From: path@squibbtaylor.com
Sent: Tuesday, April 24, 2018 2:42 PM
To: treys@squibbtaylor.com
Subject: Riser Valve Notification
Attachments: Riser Notice.pdf; Squibb Taylor Technical Sales Bulletin ST-0418.pdf

IMPORTANT TECHNICAL SALES BULLETIN ST-0418

SQUIBB-TAYLOR ANHYDROUS AMMONIA RISER VALVES POSSIBLE INCORRECT USAGE OF VALVES

Examples of the AR491NP-70 and AR493NR-95 valves illustrating the RED ID Tags and 2" NPT adapters.

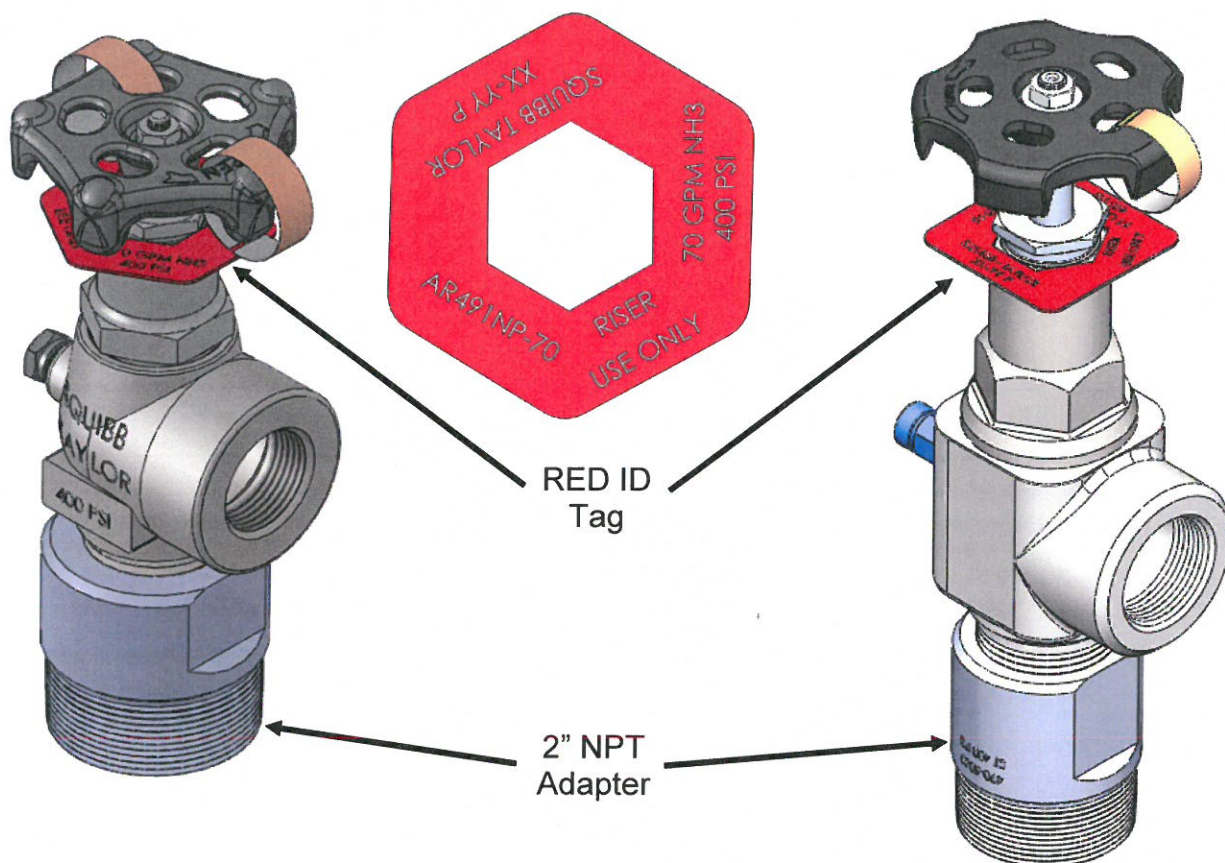
The Squibb-Taylor Riser Valves have been supplied with a 2" NPT adapter for ease of installation into the Riser systems and to deter the use of Riser valves for Nurse Tank withdrawal applications. In order to further prevent the possible inadvertent misuse of Riser valves in Nurse Tank applications, Squibb-Taylor will be introducing a new line of valves for Riser applications with the new Part Numbers AR491NP-70, AR492NP-70, AR493NR-95 and AR494NR-110. These new Riser Valves will have a large RED ID TAG (see page 2) attached below the handwheel identifying these as Riser Valves along with the rated closing flow rate and will also have the 2" NPT adapter permanently affixed to the valve for ease of installation into the Riser system.

Squibb-Taylor is discontinuing the sale of the current line of Riser Valves, Part Numbers AL477-70, AL478-70, A490NR-95 and A490NR-110 which are directly replaced by the new Part Numbers listed above.

Riser Valves						
Old Sort Number	Old part Number	New Sort Number	New Part Number	Inlet Connection	Outlet Connection	Excess Flow Rate
110575	AL477-70	110586	AR491NP-70	2" MNPT	1" FNPT	70 GPM
110590	AL478-70	110588	AR492NP-70	2" MNPT	1 1/4" FNPT	70 GPM
110595	A490NR-95	110591	AR493NR-95	2" MNPT	1 1/4" FNPT	95 GPM
110596	A490NR-110	110593	AR494NR-110	2" MNPT	1 1/4" FNPT	110 GPM
